# Access Compliance Report

## Public Rights-of-Way

Intersection ID: 44913	Main Street: SPRINGHAVEN_DR	Cross Street: OAK_DR	Location:	NE
ADA ID: 8CA2632EC20B	Ramp Type: Perp	Initial Pass/Fail: Fail	Overall Compliance: No	Severity Score: 60
Codes/Mitigation Info/Possible Solution		Field Measurements/Component Compliance

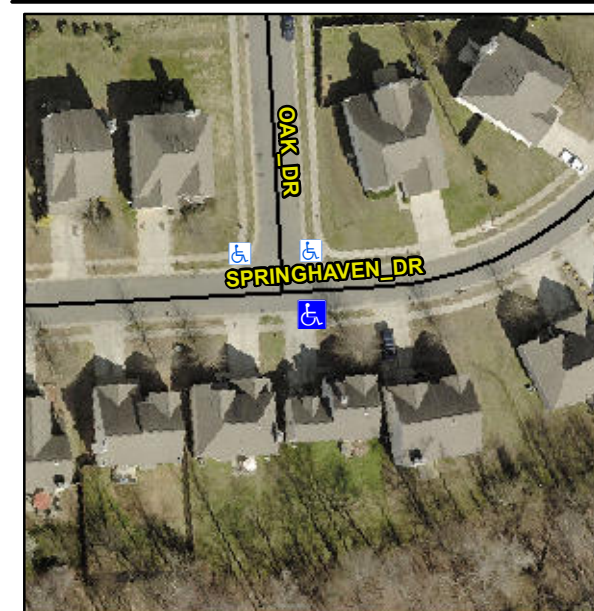
**Not Found, R304.5.1, R304.2.2**

Compliance	Description	Data	Compliance	Description	Data
N/A	Ramp Length (in)	47.0	No	Ramp Slope (%)	16.1
No	Ramp Width (in)	31.0	Yes	Ramp XSlope (%)	0.9
N/A	Flare Type LT	N/A	N/A	Flare Type RT	N/A
N/A	Flare Slope LT (%)	N/A	N/A	Flare Slope RT (%)	N/A
N/A	Flare Traversable LT?	N/A	N/A	Flare Traversable RT?	N/A
N/A	Landing Length (in)	N/A	N/A	DWS Provided?	N/A
N/A	Landing Width (in)	N/A	N/A	DWS Contrast?	N/A
N/A	Landing Slope (%)	N/A	N/A	DWS Length (in)	N/A
N/A	Landing X Slope (%)	N/A	N/A	DWS Full Width?	N/A
N/A	Landing Curb? (Y/N)	N/A	N/A	DWS Offset (in)	N/A
N/A	Shared Landing?	N/A			
N/A	Gutter Ponding?	N/A	N/A	Gutter Slope (%)	N/A
N/A	Gutter Lip Ht (in)	N/A	N/A	Gutter X Slope (%)	N/A
N/A	Painted X Walk1?	No	N/A	Painted X Walk2?	N/A
	X Walk 1 Direction	To N		X Walk 2 Direction	N/A
N/A	X Walk 1 Width (in)	N/A	N/A	X Walk 2 Width (in)	N/A
	X Walk 1 Slope (%)	2.5		X Walk 2 Slope (%)	N/A
	X Walk 1 X Slope (%)	1.6		X Walk 2 X Slope (%)	N/A

**Remove & Replace Entire Ramp.**
